Access Compliance Report

Public Rights-of-Way

(Curb Ramps)

Intersection ID: 28375	Main Street: CORNWALLIS_HALL_DR	Cross Street: WHEATFIELD_RD	Location: SW
ADA ID: D88A55E65D95	Ramp Type: PerpDiag	Initial Pass/Fail: Fail	Overall Compliance: No
Severity Score: 12.5			
Codes/Mitigation Info/Possible Solution		Field Measurements/Component Compliance

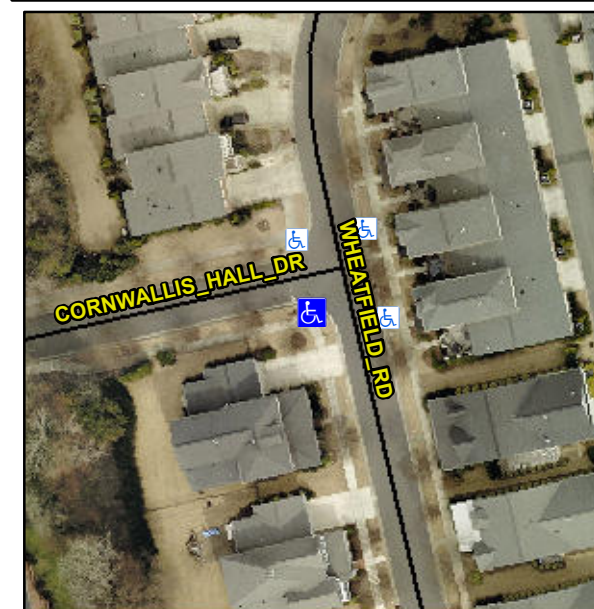
Not Found, R304.2.2

Compliance	Description	Data	Compliance	Description	Data
N/A	Ramp Length (in)	72.0	No	Ramp Slope (%)	11.1
Yes	Ramp Width (in)	48.0	Yes	Ramp XSlope (%)	0.9
N/A	Flare Type LT	N/A	N/A	Flare Type RT	N/A
N/A	Flare Slope LT (%)	N/A	N/A	Flare Slope RT (%)	N/A
N/A	Flare Traversable LT?	N/A	N/A	Flare Traversable RT?	N/A
N/A	Landing Length (in)	N/A	N/A	DWS Provided?	N/A
N/A	Landing Width (in)	N/A	N/A	DWS Contrast?	N/A
N/A	Landing Slope (%)	N/A	N/A	DWS Length (in)	N/A
N/A	Landing X Slope (%)	N/A	N/A	DWS Full Width?	N/A
N/A	Landing Curb? (Y/N)	N/A	N/A	DWS Offset (in)	N/A
N/A	Shared Landing?	N/A			
N/A	Gutter Ponding?	N/A	N/A	Gutter Slope (%)	N/A
N/A	Gutter Lip Ht (in)	N/A	N/A	Gutter X Slope (%)	N/A
N/A	Painted X Walk1?	No	N/A	Painted X Walk2?	No
	X Walk 1 Direction	To E		X Walk 2 Direction	To N
N/A	X Walk 1 Width (in)	N/A	N/A	X Walk 2 Width (in)	N/A
	X Walk 1 Slope (%)	4.9		X Walk 2 Slope (%)	3.2
	X Walk 1 X Slope (%)	0.7		X Walk 2 X Slope (%)	2.4

Remove & Replace Curb Ramp With Two New Directional Ramps or Equivalent.
